Change Nr, Title 20009207, Update bom for 800571 tox process
Date of issue 24.02.2023

800571 FN530-16-99

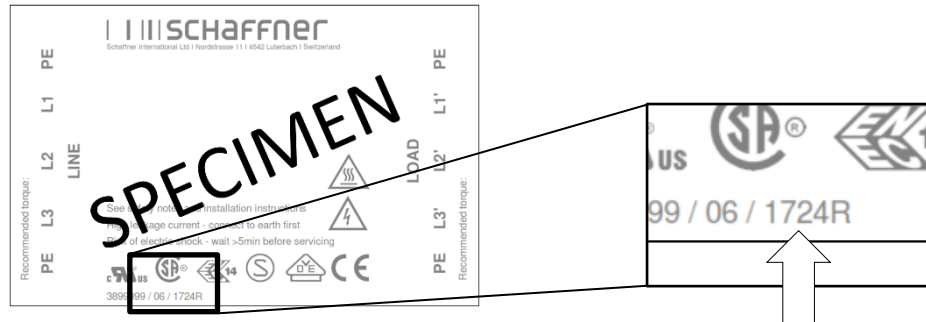
The housing assembly process was changed from tox clinching to riveting.

Better connection

Rivets are visible in the housing sheet metal.
